Appln. No. 10/827,343
Amdt. dated March 8, 2006
Reply to Office Action of November 8, 2005

Amendments to the Drawings

FIG. 5

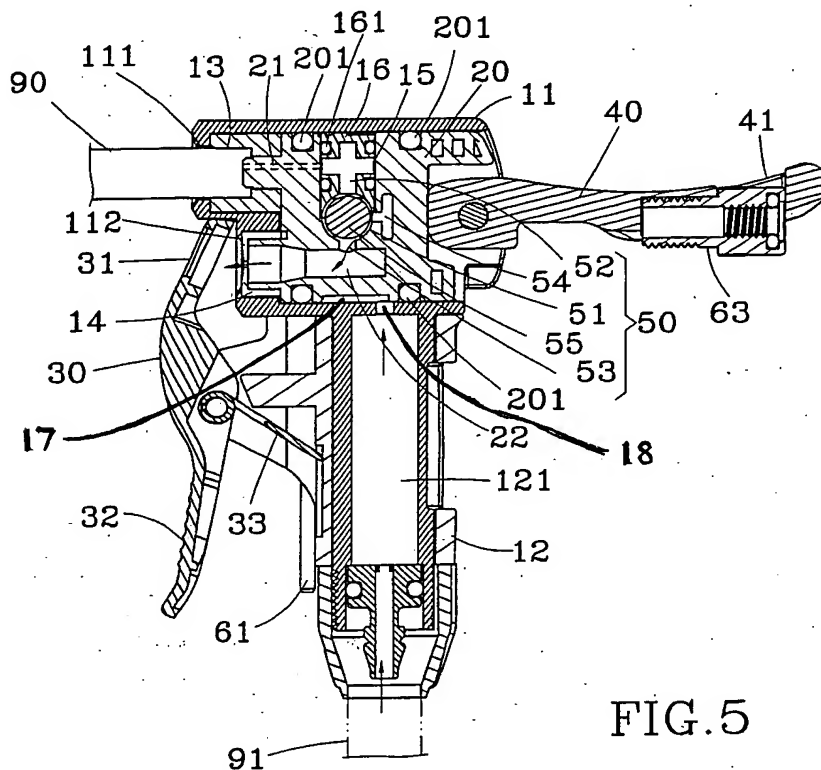
The attached sheet of drawings includes changes to Fig. 5-6. This sheet, which includes Figs. 5 and 6, replaces the original sheet including Figs. 5-6. In Figs. 5-6, previously omitted elements 17 and 18 have been added.

FIG. 6

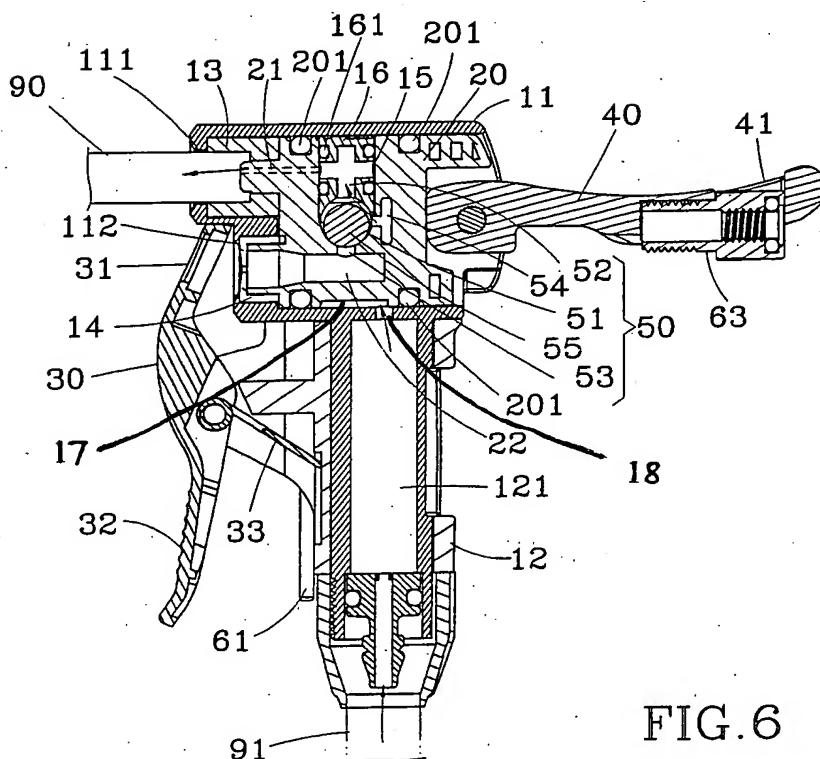
(12) to interact with the switch valve (50) to exit out of the casing head (11) through the first and second holes (111 and 112). Fig. 6 of the application clearly shows an arrow showing the movement of air from air inlet 121 through admitting hole 18 into interstice 17 where it then travels to exit out of casing head 11. Applicant submits that interstice 17 and admitting hole 18 are not inventive features of the claimed invention, as both are prior art clearly taught by interstice 19 and admitting hole 11 of U.S. Patent 5,960,815 to Applicant.
